# SERVICE BULLETIN III

62

#### **FLAP LEVER PROOF TEST**

All T67M260-T3A aircraft.

FIGURE 1

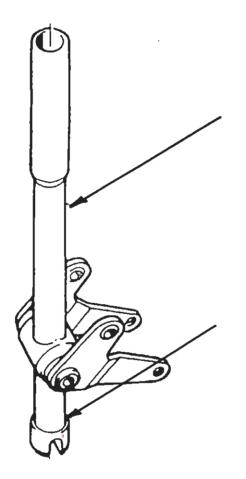
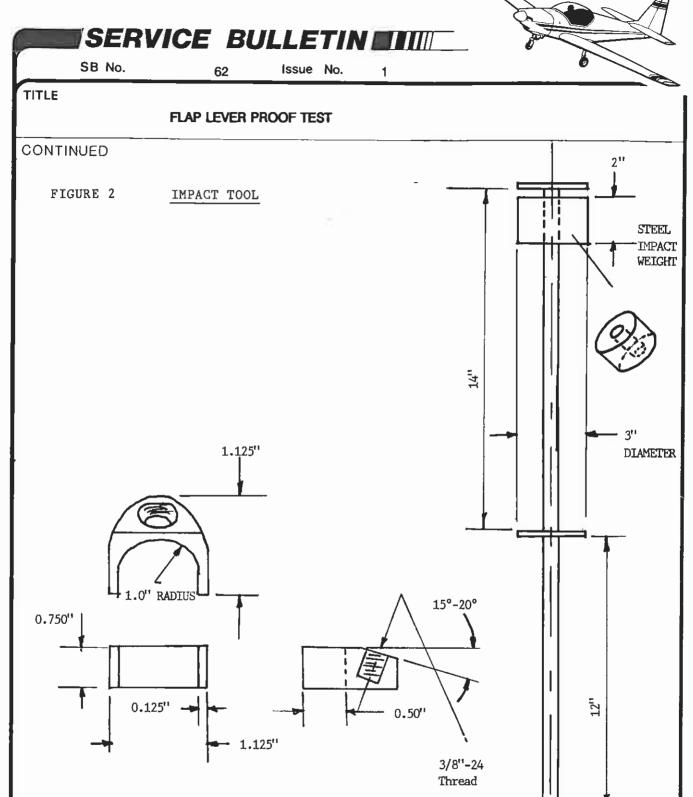
- 1. Place flap operating handle in the aft position (landing flap).
- 2. Remove centre console cover.
- 3. Put impact tool formed end between flap lever return springs and work into place with the concave side around the flap operating handle. Put the end of the tool against the shoulder of the end plug with the shaft of the tool angled forward.
- 4. Place the impact weight at the top of its travel above the strike plate and allow it to free fall and listen to the sound. A dull sound on impact may indicate an inadequate joint in the form of paint cracking or a gap between the end plug and the tube.
- 5. Repeat Action 4.
- 6. Inspect, using a strong light, to determine any evidence of failure in the brazed joint.
  - (l) If no damage present, apply touch-up coat of paint, if necessary, and certify item to be serviceable.

(ii) If the end plug breaks free or the brazed joint has been damaged, before further flight remove flap lever assembly, strip down the flap lever completely and replace with:

- (a) A brazed and proof tested flap lever assy, Part No. T67B-45-216/T or:
- (b) A welded flap lever assy, Part No. T67B-45-262. Annotate Aircraft Log Book "Mod M645 Incorporated".
- 7. Return any falled flap lever assemblies to Slingsby Aviation.
- 8. Report all findings, cross referenced to aircraft serial number, to Slingsby Aviation.
